Thank you for the referral via the Planning Portal inviting the NSW National Parks and Wildlife Service (NPWS) to provide advice on development application DA/12/2024 for the Construction and Operation of the South Cell at Woy Woy Waste Management Facility (WMF).

NPWS has identified the following queries and concerns in relation to DA/12/2024.

Figure 1 – Approximate location of suggested water quality monitoring point immediately upstream of where Patonga Creek enters BWNP.

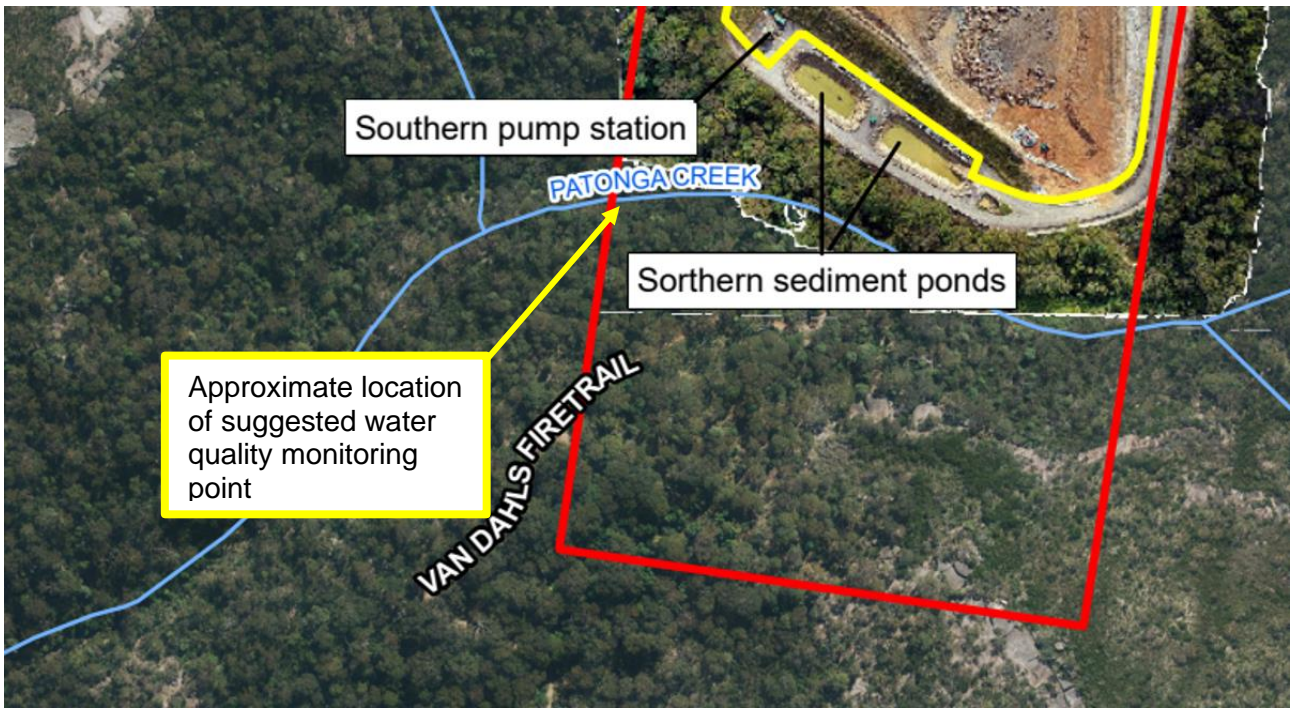
Patonga Creek enters BWNP approximately 100m downstream of where the high flow overflow water enters the creek. NPWS has concerns about the potential impact of sediment laden water on the waterway health of Patonga Creek within BWNP.

NPWS requests further information regarding what (if any) measures are taken to ensure that this overflow water does not contain sediment.

Furthermore, NPWS recommends that as part of the development consent a water quality monitoring station be established immediately upstream of where Patonga Creek enters BWNP (see Figure 1 attached) and that Central Coast Council notifies NPWS when the sediment pond overflow system is activated and this water is realised into Patonga Creek.
